SERVICE BULLETIN

Classification: EL12-034	Reference: NTB12-043	Date: May 4, 2012
-----------------------------	-------------------------	----------------------

2008 – 2012 ROGUE ENGINE HARNESS REPLACEMENT

APPLIED VEHICLES: 2008 – 2012 Rogue (S35)

Figure 1

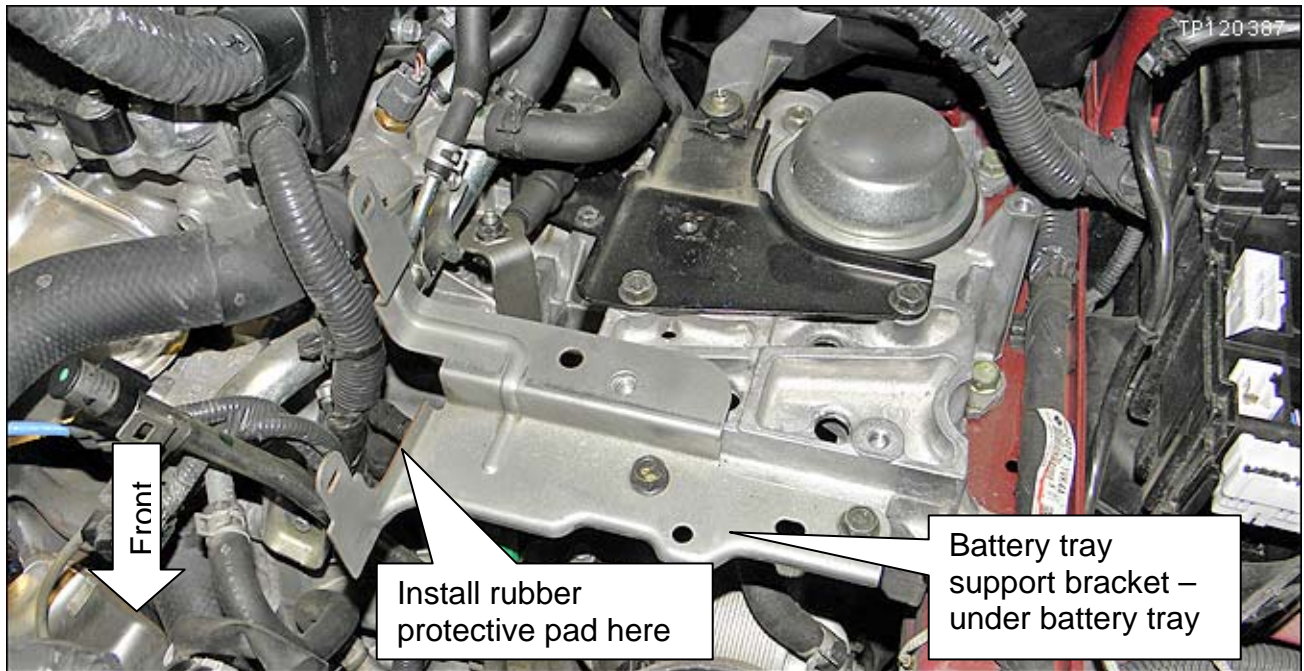
If for any reason the engine harness is replaced, during the replacement of the harness, install a rubber protective pad on the battery tray support bracket at the location shown in Figure 1 below. Refer to the Service Procedure for installation instructions.

Figure 2

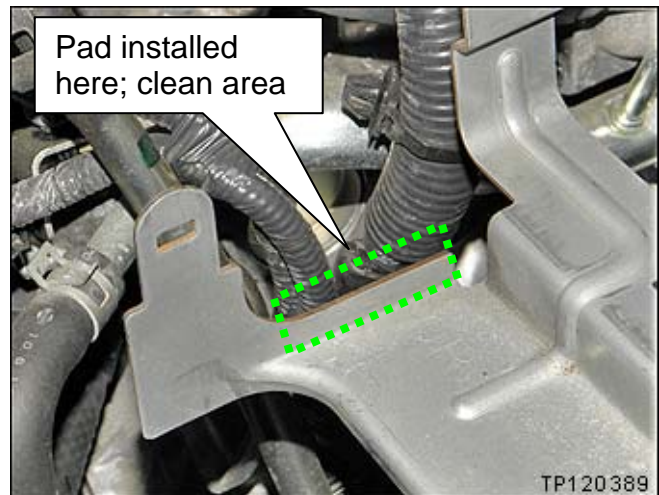
2. Clean the area where the protective pad will be installed.
 - Installation area is shown with dashed line.
 - Clean both sides of the bracket edge. Pad will be folded over and attached to both sides.

Figure 3

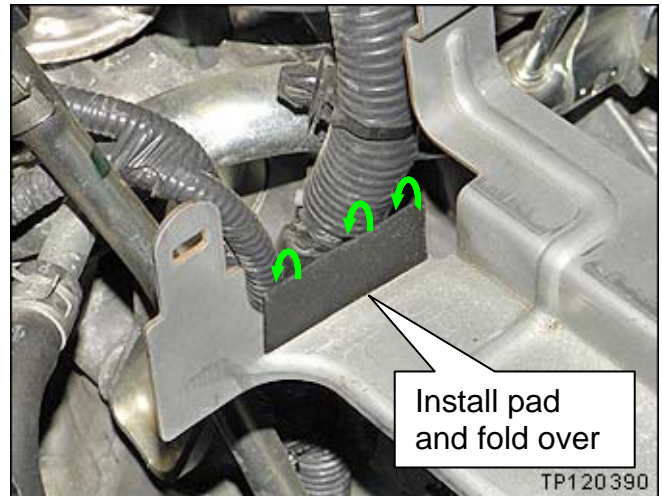
3. Attach the rubber protective pad as shown.
4. Fold the protective pad over the bracket edge so it covers and sticks to both side.
